RE: Site Plan Review-Peer Review
#1355 Main Street Energy Storage System (ESS)
ZP Battery Devco, LLC
Map 26/Parcel A1

SITE DEVELOPMENT PLAN SOLAR ENERGY STORAGE SYSTEM (ESS)

1355 MAIN STREET

PROJECT SIGHT LINE
HORIZONTAL SCALE=1": 40' VERTICAL SCALE=1": 4'

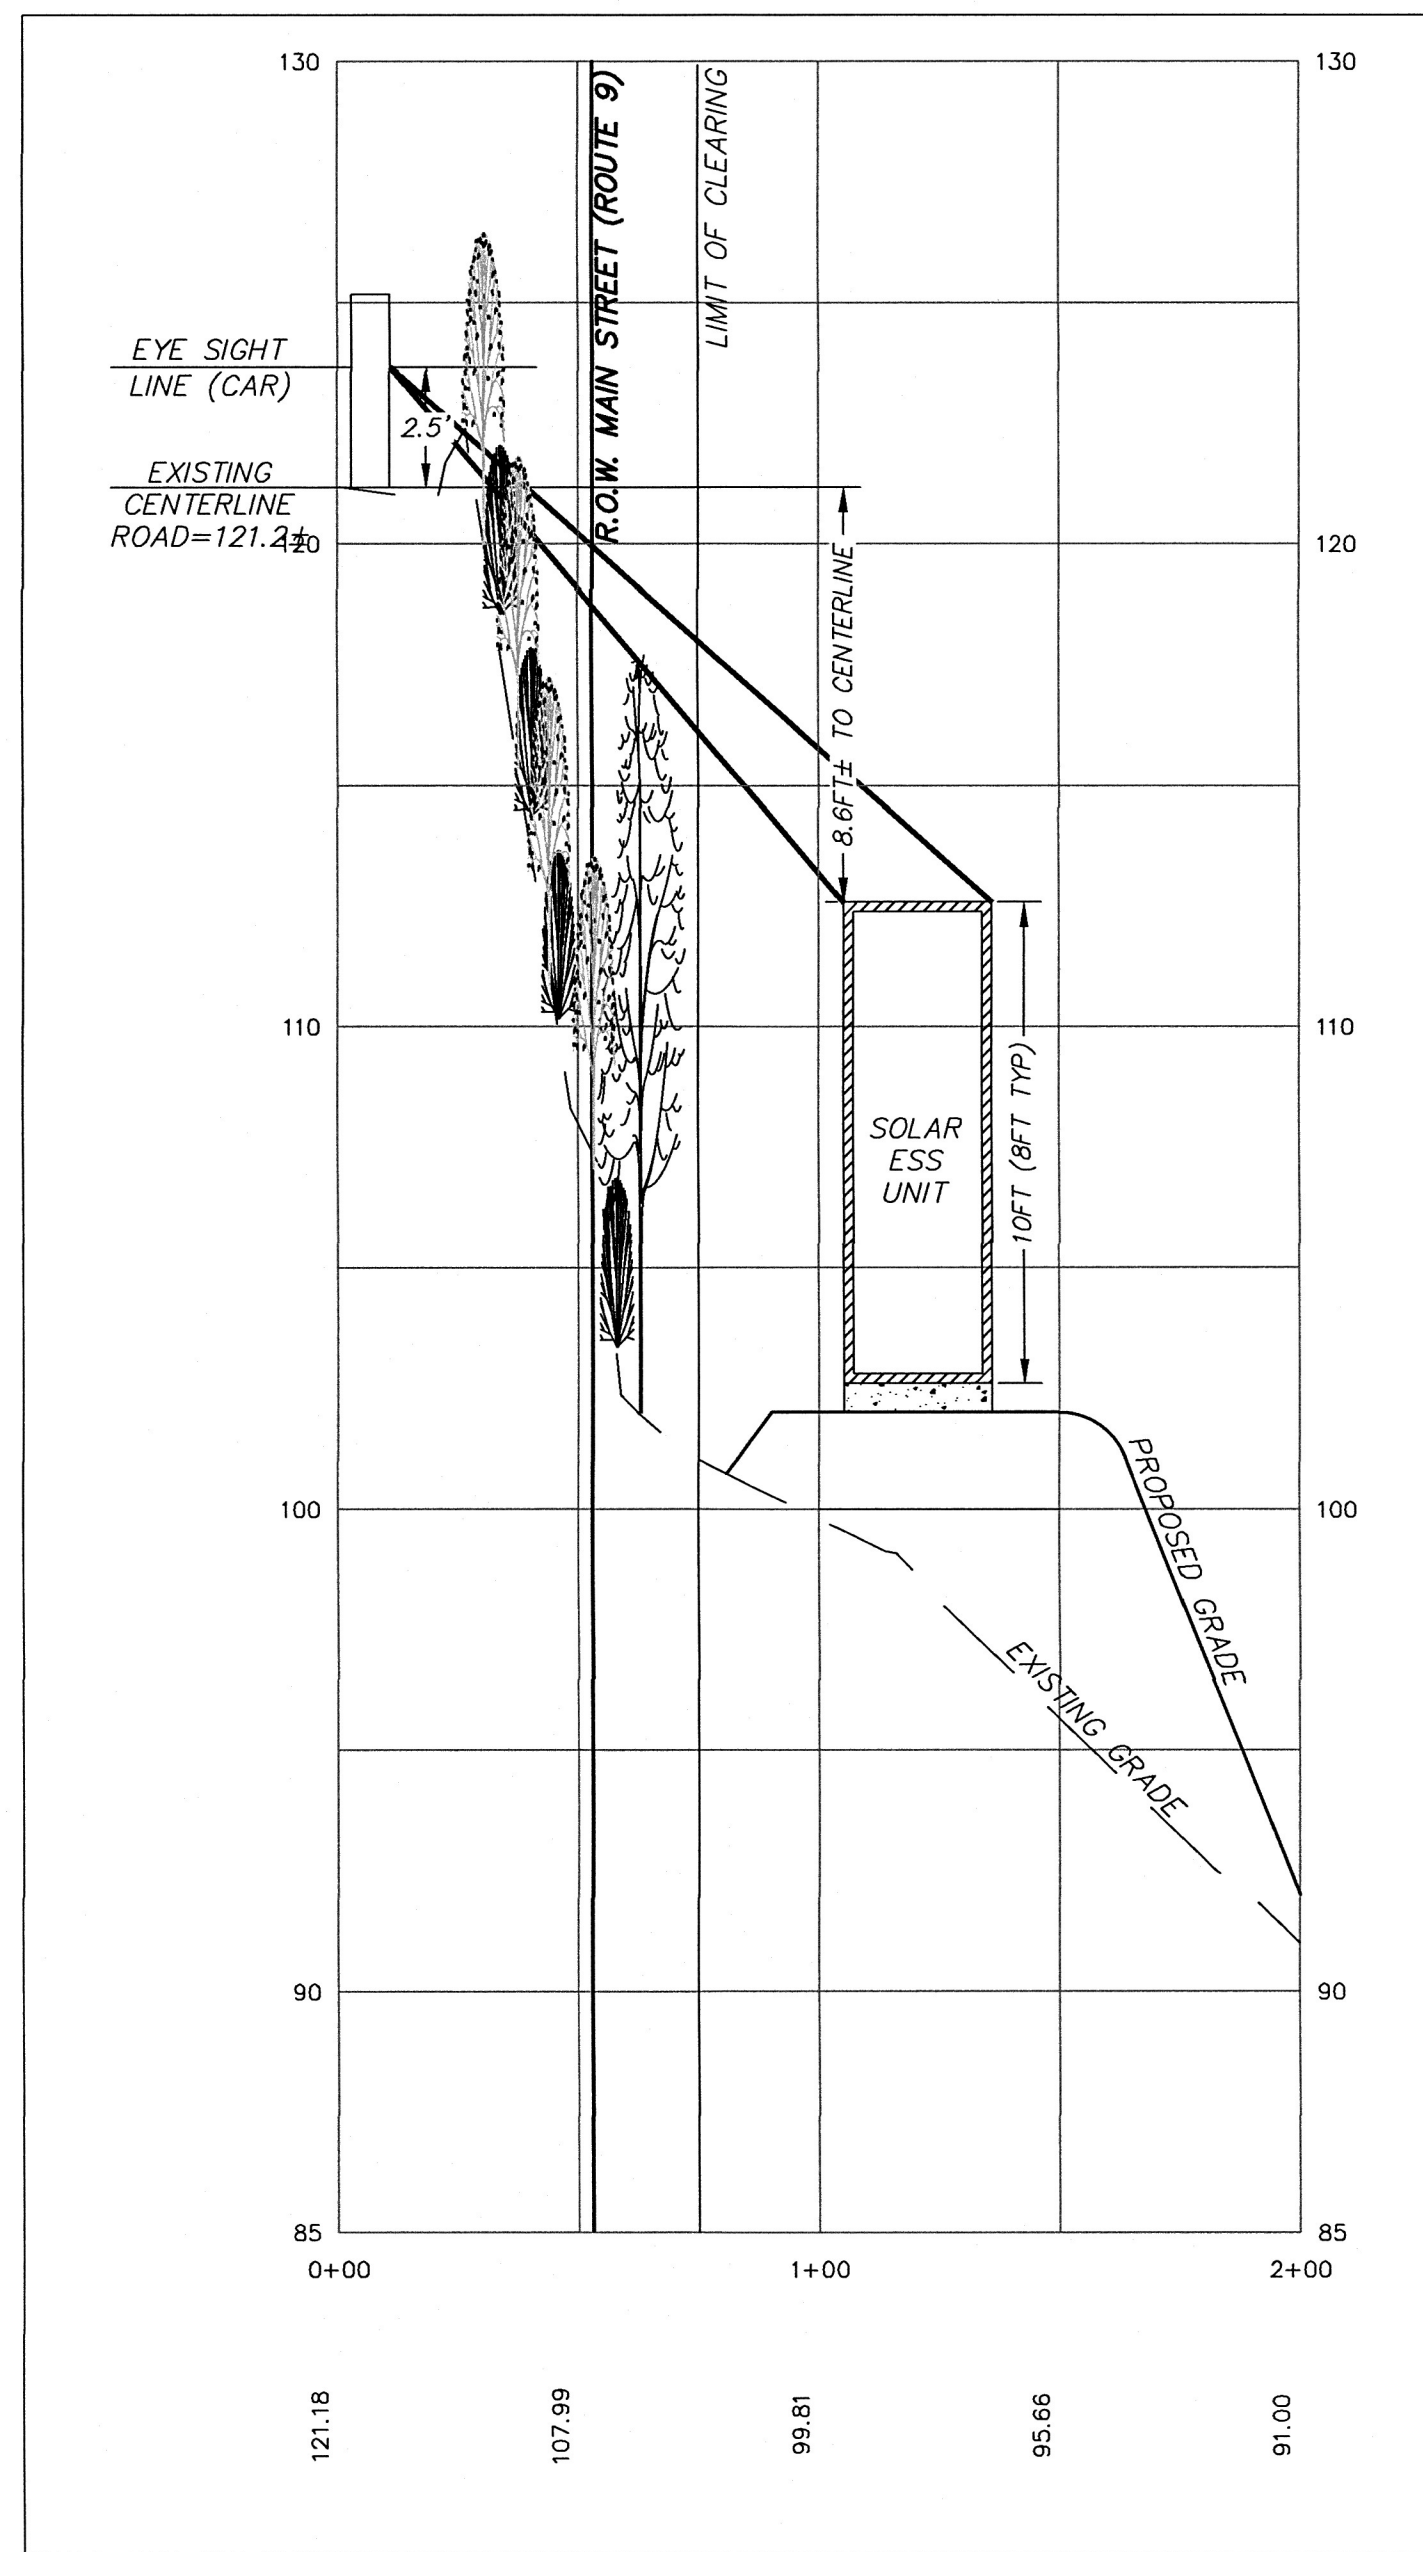
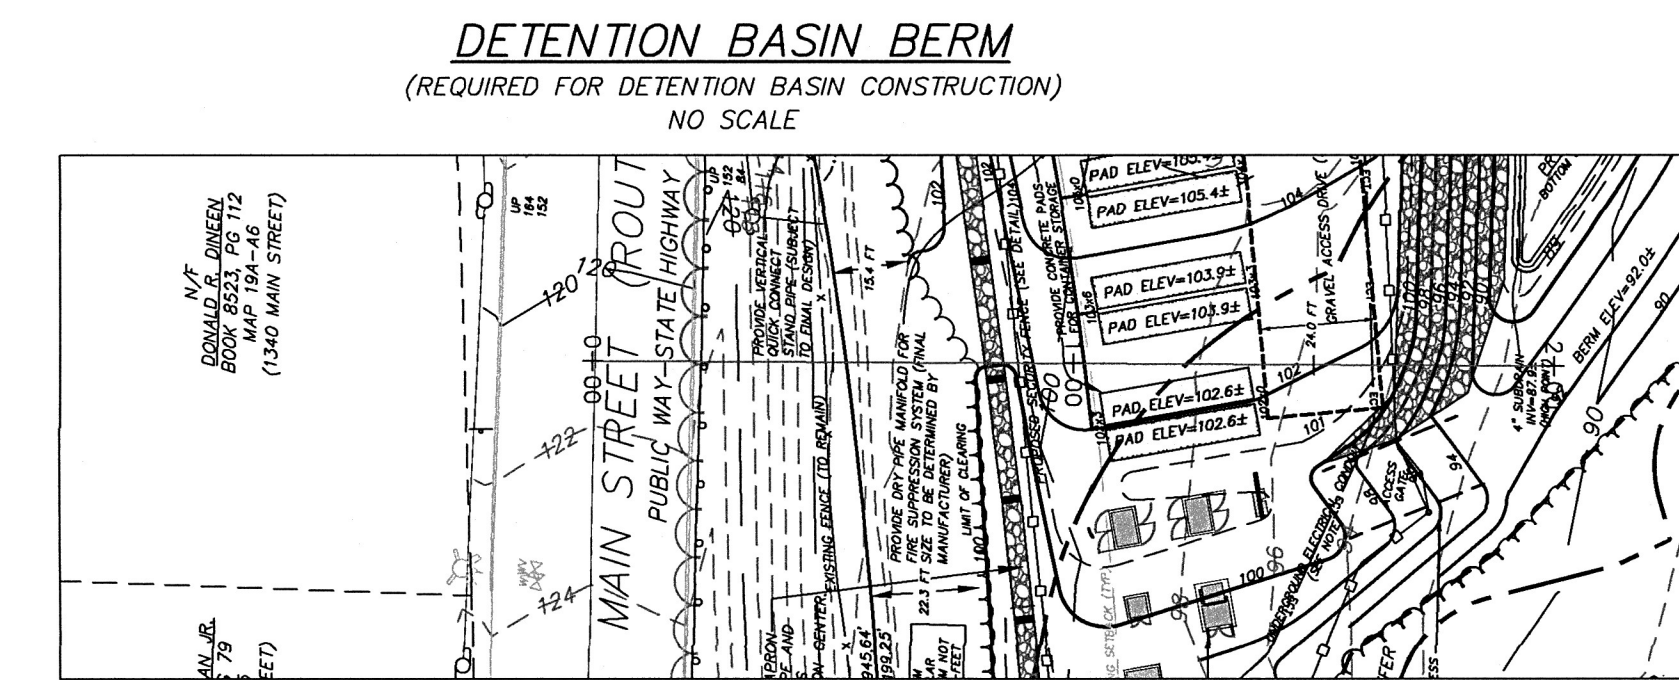
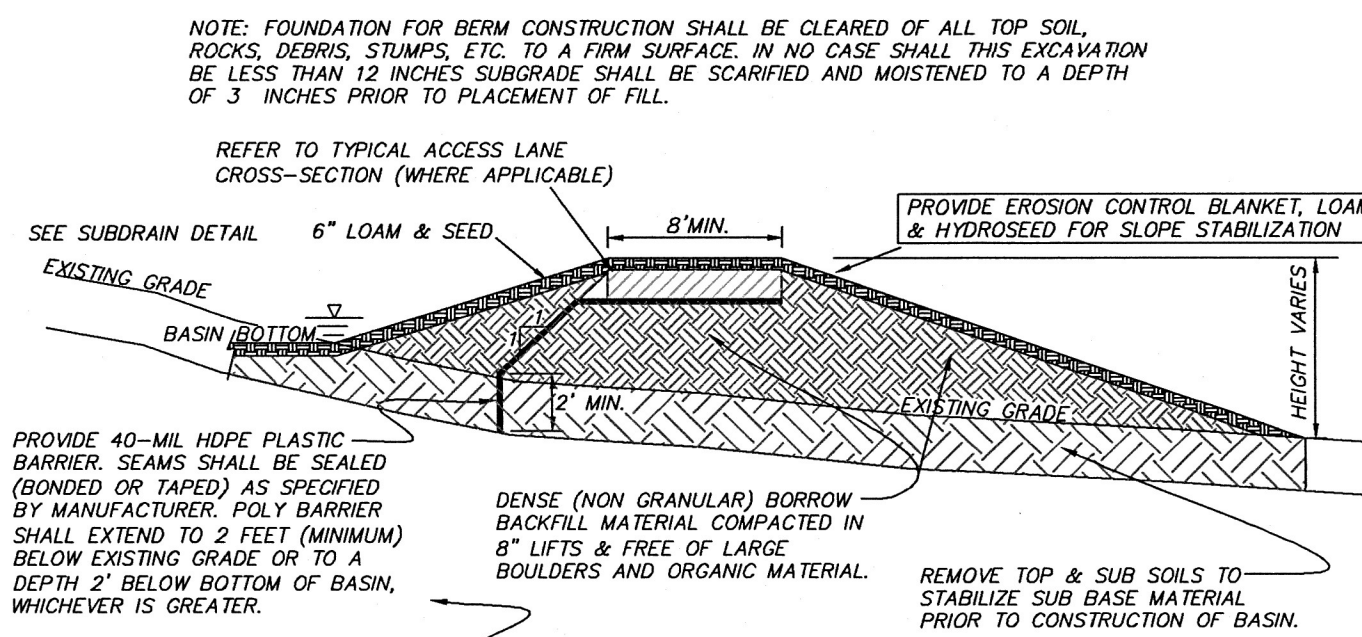
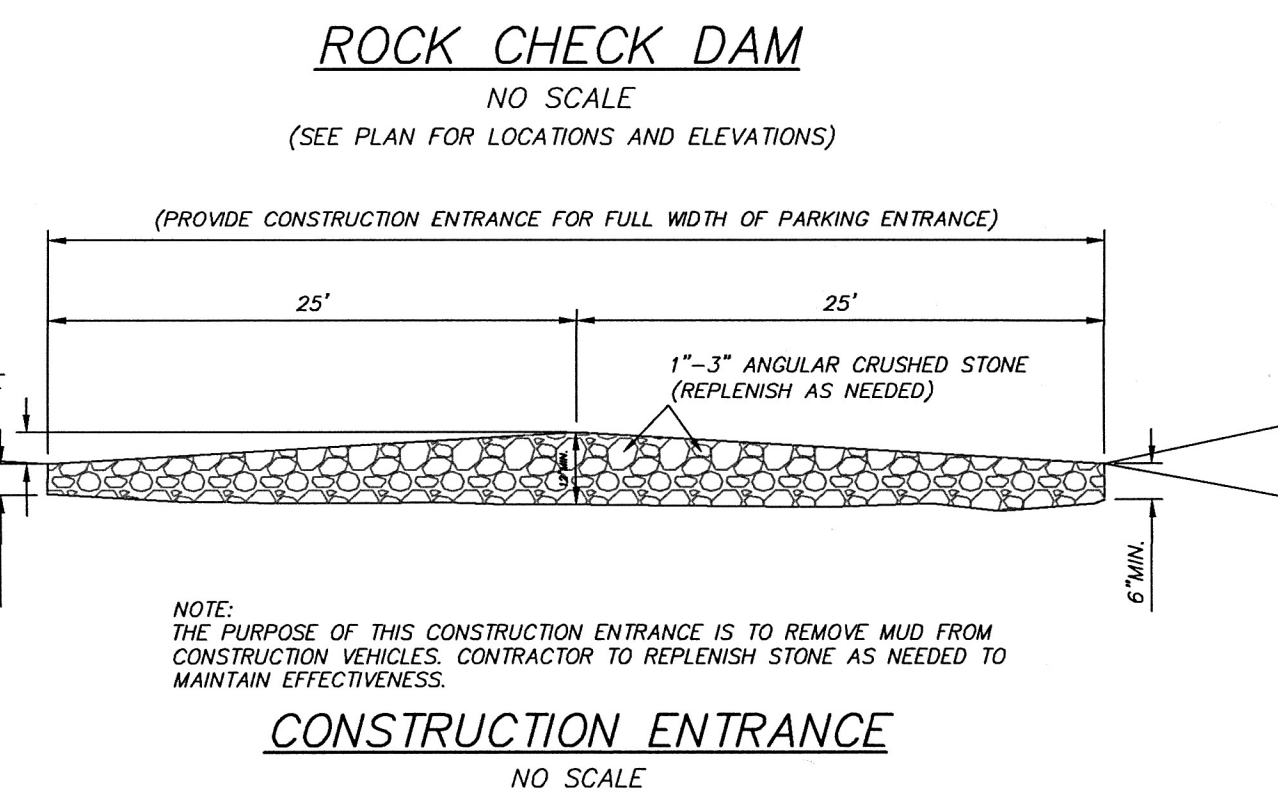
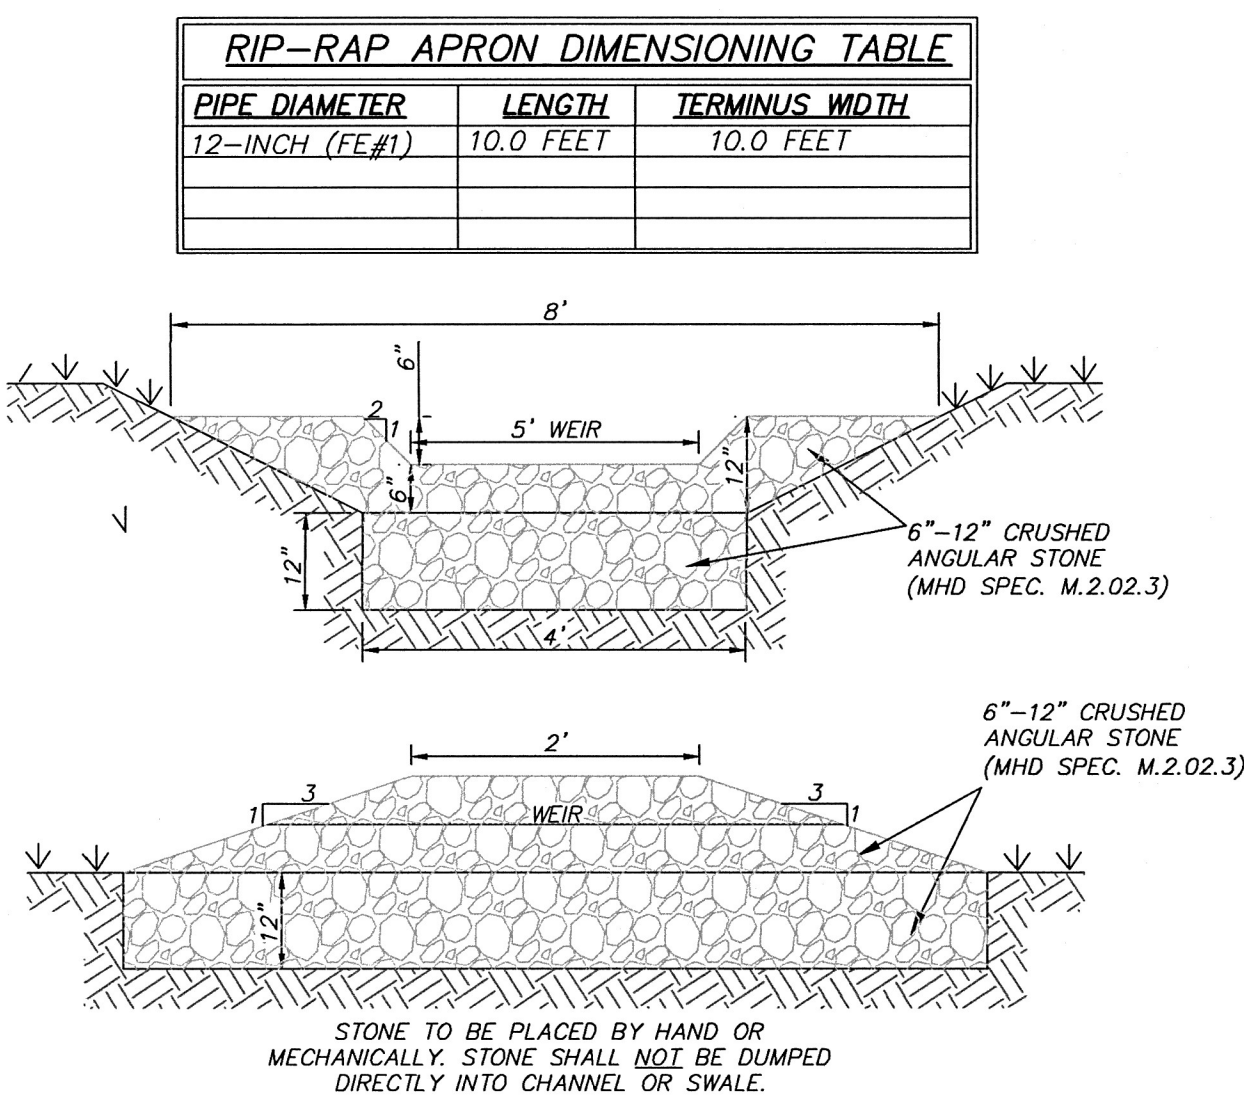
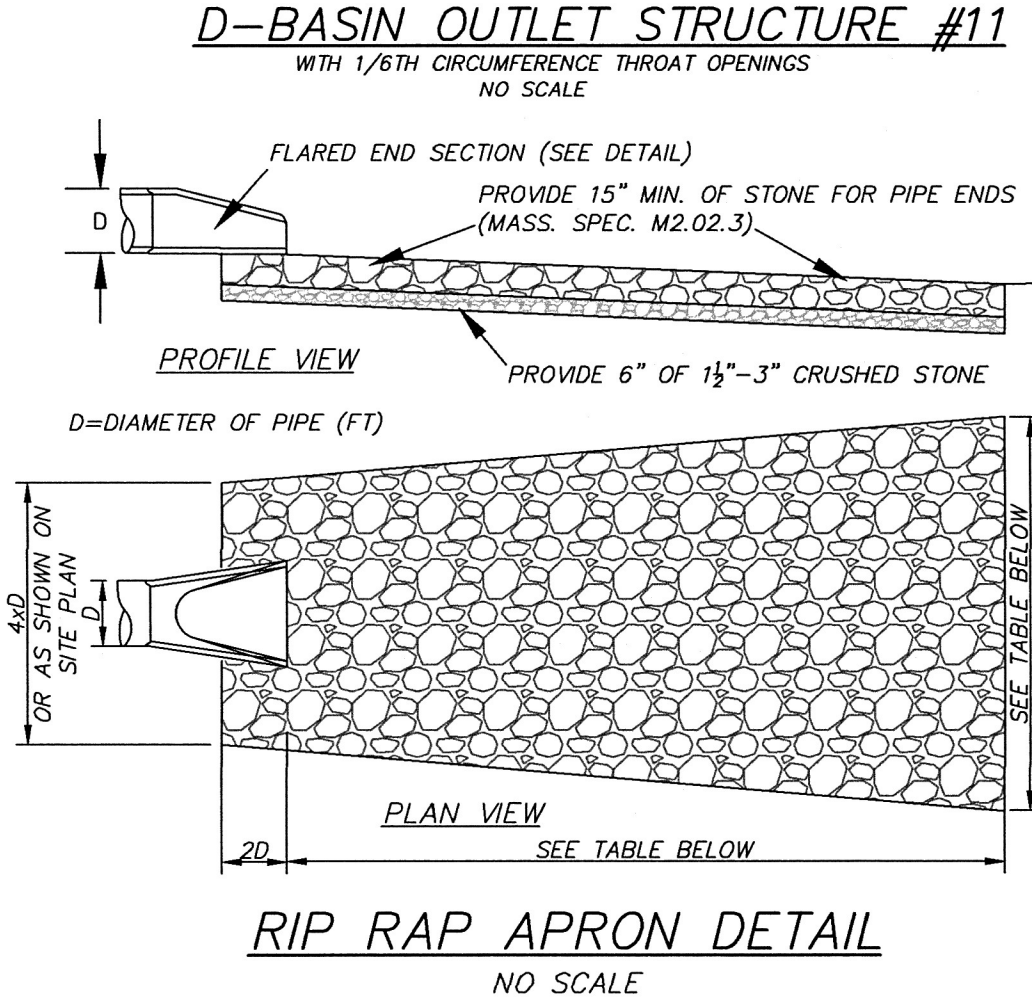
Comment #6: Post Construction View Representations are required under SPRR II.K.2. The conceptual renderings provided in the application generally depict the proposed ESS components but do not appear to represent the specific configuration at this site. This office defers to the Board if the conceptual renderings are sufficient or if the renderings must be updated.

*Comment #6 10/28/21: **This office defers to the Board.** Hannigan Engineering, Inc. has indicated that a profile depicting the elevation relief and layout of the system has been provided to aid in review. This office defers to the Board if the conceptual renderings are sufficient or if the renderings must be updated*

- The proposed Energy Storage Systems (ESS) are located on the property such that the units are located well below the abutting roadway elevation. The elevation relief from the roadway to concrete pads vary approximately 12-feet to 18-feet along the length of the project, with an average height of approximately 8-feet per ESS, the top of the units are still approximately 4-feet to 6-feet below the existing grade of the roadway. This in combination with the woodland and brush that is intended to remain it is anticipated to shield the ESS units from the abutting roadway as well as the residential properties located along the opposite side of Main Street. Reference is also made to the included sightline profile from the roadway to the ESS System to document the extent of the elevation relief.
